Planning
Assessment
Commission

Kendall Bay Marina Project

PAC Report

20 April 2011

Figure 5.2 Map showing the plans for the Marina and the area of the Bay proposed to be covered by the geotextile blanket

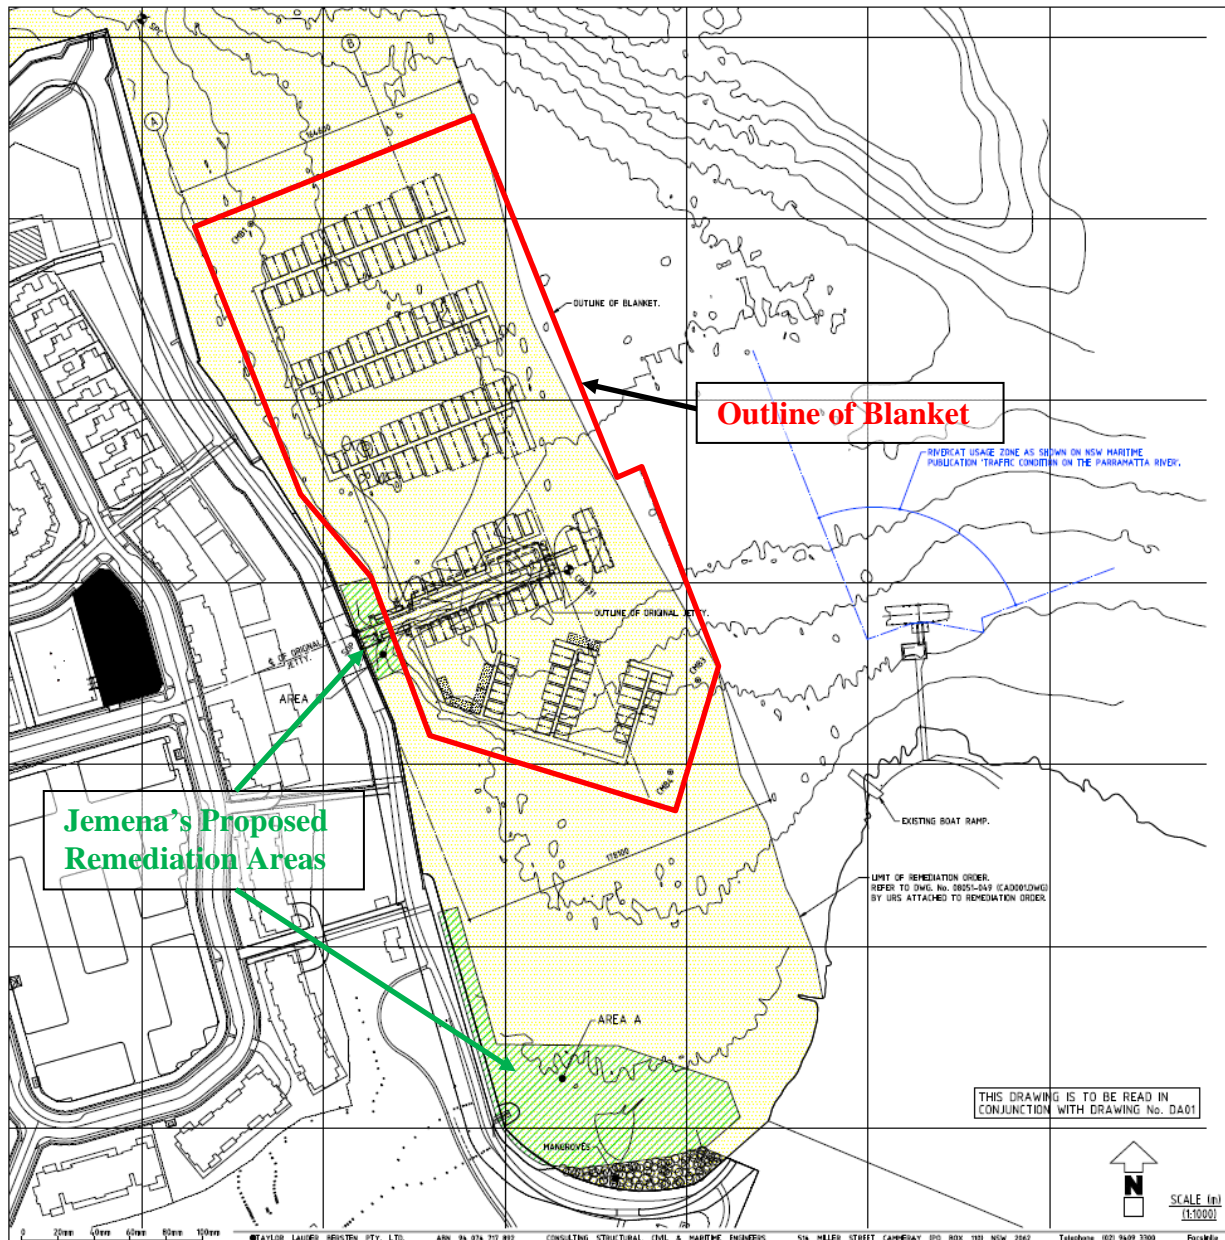
The Proponent has proposed the use of a geotextile cover over bottom sediments that would encompass an area directly below the proposed Marina and extending beyond as shown in Figure 5.2. Some 168 piles supporting the Marina structure will go through the proposed 7 mm thick geotextile cover and will be appropriately sealed to prevent sediment egress. The geotextile blanket will be covered with basalt rock fragments to a depth of approximately 300 mm, with the objective of holding the blanket in place. The Proponent advises that the size of these rocks will average around 100 - 220 mm.

Seals will be made for 168 piles that will be driven through the cap in construction of the Marina. Further natural sedimentation would form on the cap during the life of the Marina.

The Commission requested evidence from the Proponent in support of the claim for the life of the cap. The Proponent has provided evidence of satisfactory life of geotextile blankets in situations of severe physical stress of the order of 20-30 years (Heerten, 1984; Rollin, 2004). Modelling has been proposed for extension of life projections to longer periods but, in the Commission's opinion, such models without validation provide little assurance. Depending on the choice of polymers, resistance to chemical deterioration can be demonstrated in the medium term. The problem in the proposed situation is that chemical, biological and physical factors will combine in ways difficult to simulate in laboratory tests. These factors pose a threat to the long-term integrity of the geotextile material. The conditions in the contaminated sediment below the blanket will be anaerobic and the interaction of anaerobic microorganisms with the contaminants present in such a way as to cause deterioration of the blanket, or to increase mobility of some of the contaminants, cannot be discounted.

All other evidence to the Commission suggested a considerably shorter life, with DECCW suggesting 30 years might be a more realistic figure. The Commission's view accords with that of DECCW and, for the purposes of its assessment, the Commission considers that the geotextile blanket with rock armour layer may be physically stable for 30 years if installed and operated as proposed. But there remains considerable uncertainty as to the effectiveness in terms of re-suspension and/or loss of contaminants.

Figure 5.3 Current Water Depth at Lowest Astronomical Tide

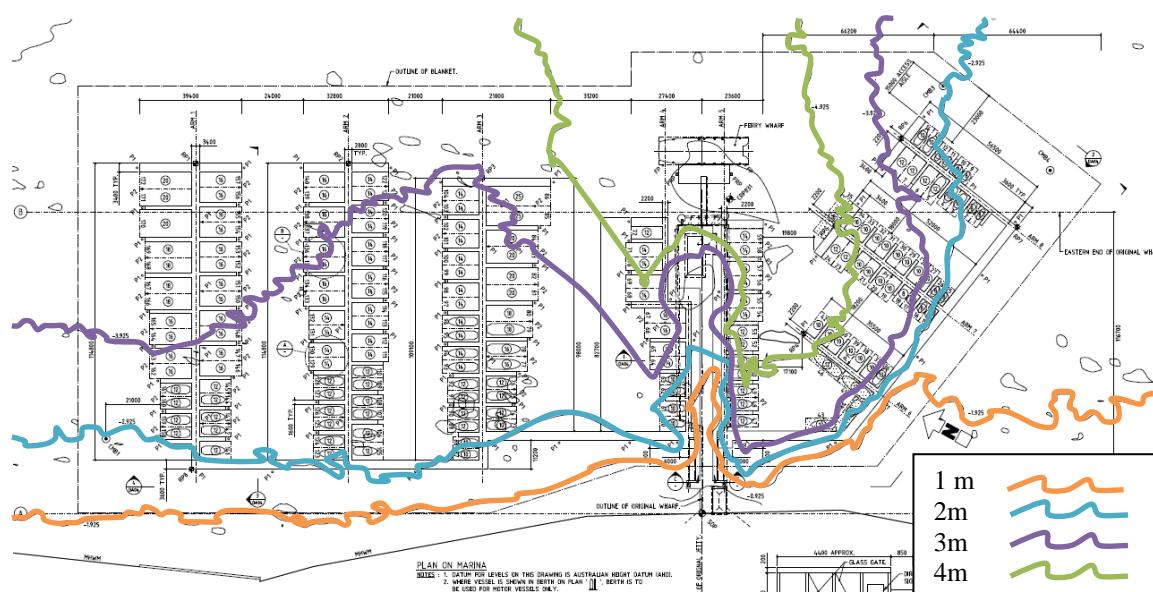
This table shows that with a thicker 1.5 m cap a large proportion of the proposed berths (approx 65%) would have a draft of less than 1.5 m at low tide. To ensure the cap was not damaged it would therefore appear necessary to significantly reduce the number of medium-

sized craft allowed to moor at the Marina and to also reduce the total number of craft that could be accommodated. The reduction in size would involve the inshore boundary of the Marina moving further out into the Bay. Whether such an arrangement still resulted in a viable marina design would require a new layout of marina berths to be prepared. The Commission considers that the added depth restriction would significantly detract from the functionality of the proposed Marina, if an appropriate margin of safety in depth was allowed for protection of the cap against the stress of propeller-induced turbulence.

Figure 6.1 Access to the proposed Marina shown in green arrows, (illegal, but currently unrestricted access shown in red)

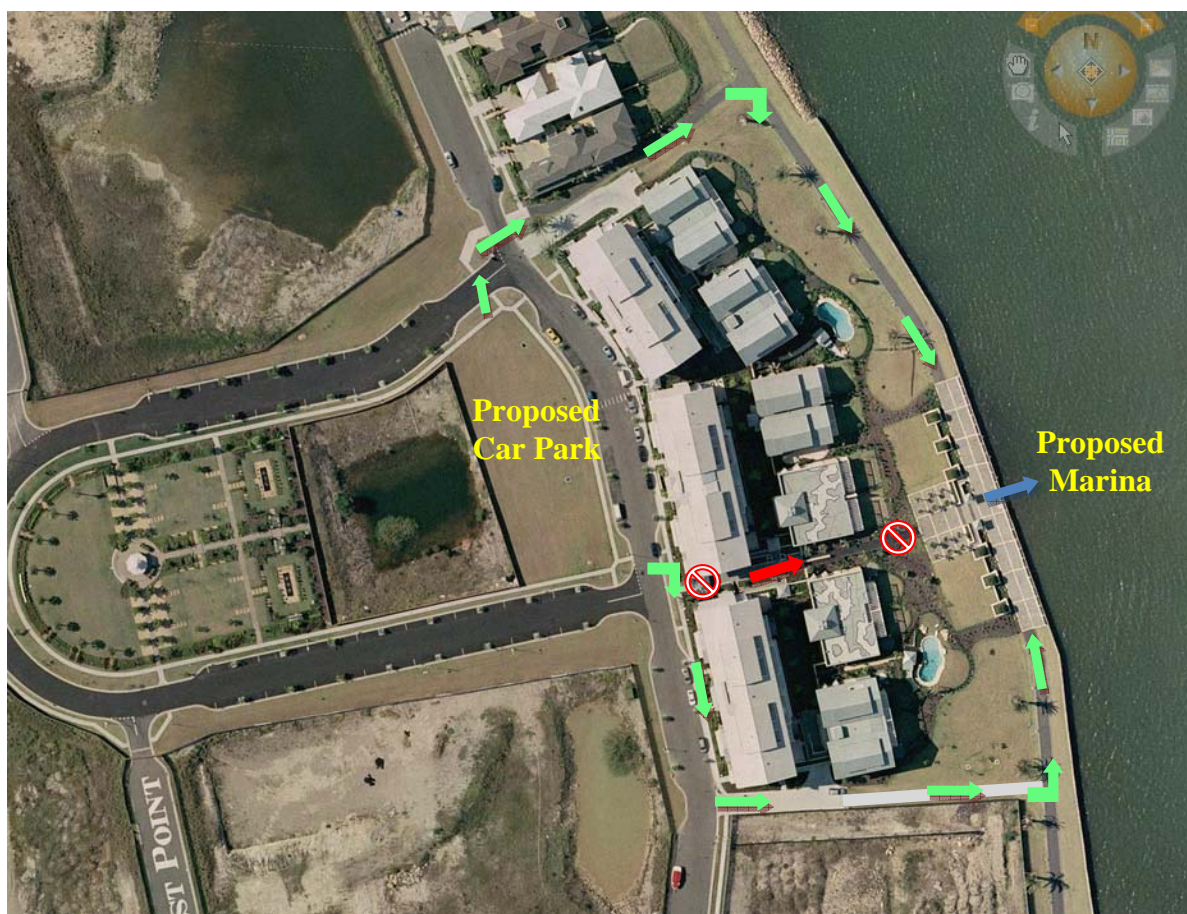
Due to the layout of the existing residential development and the presence of the foreshore walkway, the proposed Marina would not have direct vehicle access. The proposal would include 58 car-parking spaces, however these would be provided on a separate parcel of land, approximately 100 m west of the Marina site.

Access from the car park to the Marina would be via existing footpaths which run around the residential buildings fronting the foreshore (see Figure 6.1). Using these footpaths, pedestrians and their goods would have to travel between 230 to 300 m to reach the entrance to the Marina. Depending on the location of their vessel, marina users could have to travel almost as far again to get to their vessel (a total of up to 600 m from the car park to the vessel). Goods were originally proposed to be transported from the car park to the Marina, and associated vessels, using motorised golf buggies. In response to community concerns about the use of these vehicles, the Proponent has now suggested using hand-drawn trolleys, although the Commission has some concerns about the practicalities of this option (see Section 6.2.3).

Practically, access can also currently be gained by walking between the buildings in the Hunter Wharf Strata Title (as shown by the red arrow in Figure 6.1). This access route would be much more convenient, but is through private land and is consequently illegal. It is unclear how the Marina operator would prevent the use of this walkway.

Figure 6.2 Closest vehicle access

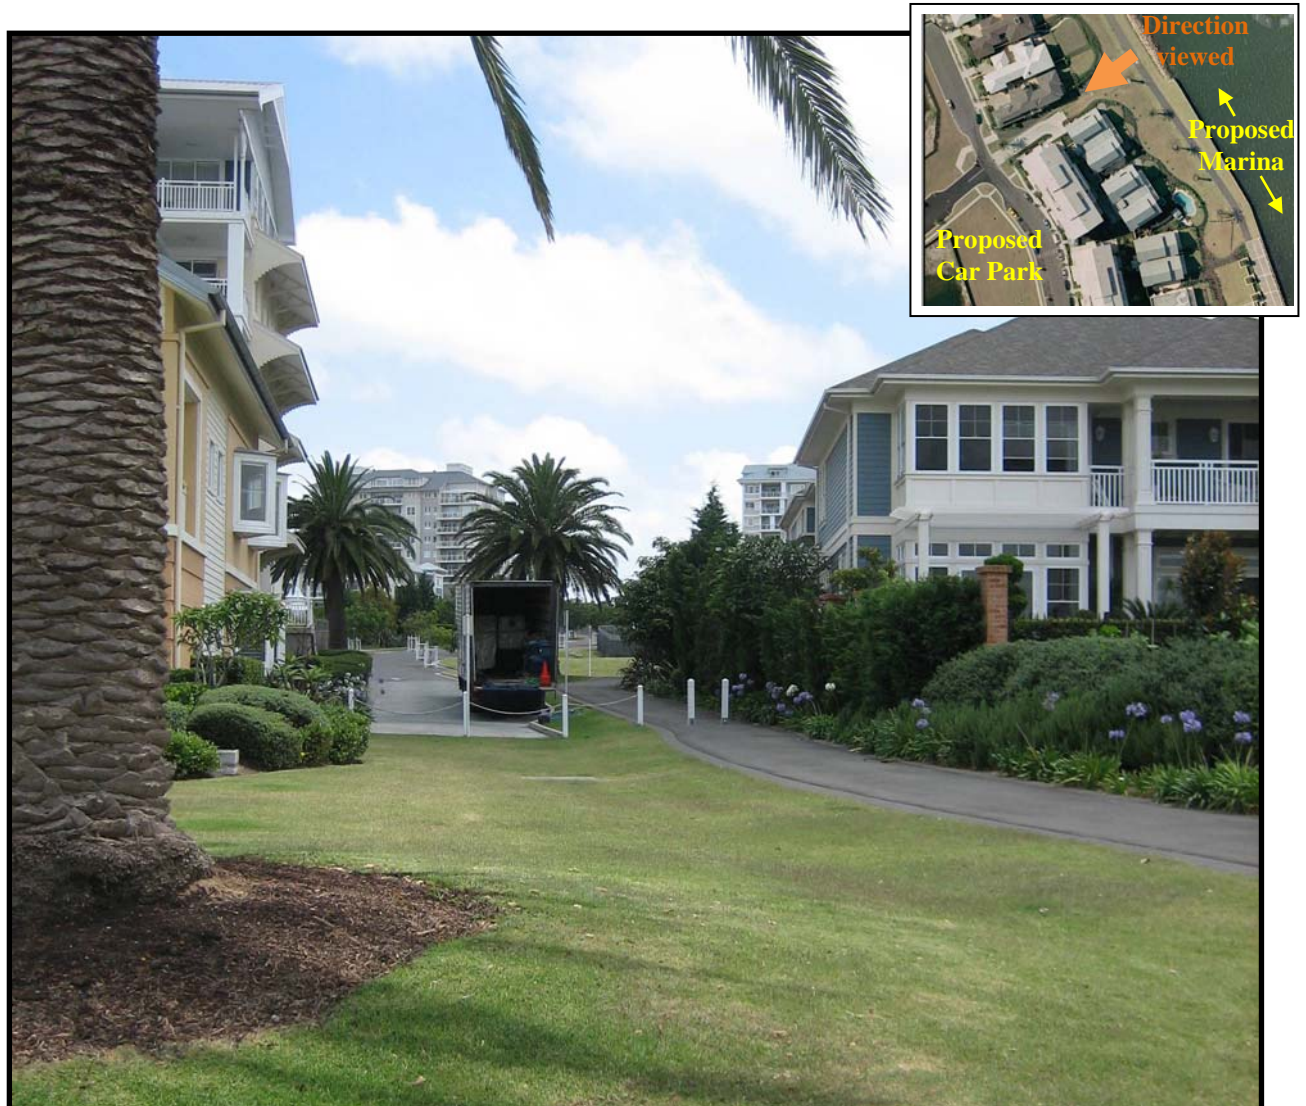
As discussed early in this section, it is at least 230 m from the nearest parking space in the car park to the entrance to the Marina, and then up to 300 m more again to get to the furthest vessel. The logistics of carrying supplies and equipment between the car park and the Marina are considered impractical. Even with a cart or motorised buggy, patrons would have to cross 2 roads and navigate between pedestrians, on a sloping footpath, down to the foreshore and then around the Marina.

The first issue relates to access for emergency service vehicles that may need to respond to emergencies such as a fire or explosion on the Marina. As shown in Figure 6.2 and Figure 6.3, vehicle access to the foreshore is restricted by a small fence. While it would be possible to ensure the fence is designed to be easily removed, residents have raised concerns that vehicles responding to an emergency would not have time to worry about damaging the property of the Community Association and that emergency vehicles would drive over the barrier, or through the garden bed. Furthermore, submissions expressed concerns about the structural capacity of the sea wall, suggesting that it may not have been designed and constructed to the standard required to support multiple fire engines and associated equipment that would be required to respond to a major incident at the Marina.

In response to these concerns, the Proponent has confirmed that the seawall is structurally sufficient to withstand the loads arising from emergency vehicles standing on the pavement and also that the pavement is sufficient to support these loads.
